Access Compliance Report

Public Rights-of-Way

(Curb Ramps)

Intersection ID: 49251	Main Street: RIDGE_PATH_LN	Cross Street: PROSPERITY_RIDGE_RD	Location:	N
ADA ID: 001E971E889D	Ramp Type: Perp	Initial Pass/Fail: Pass	Overall Compliance: No	Severity Score: 7.75
Codes/Mitigation Info/Possible Solution		Field Measurements/Component Compliance

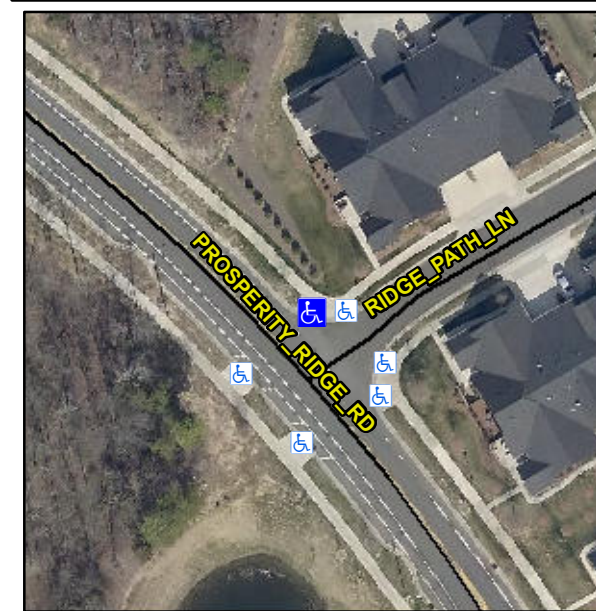
**Remove & Replace Entire Ramp.
Remove & Replace Gutter.**

R304.5.3, R302.7.2
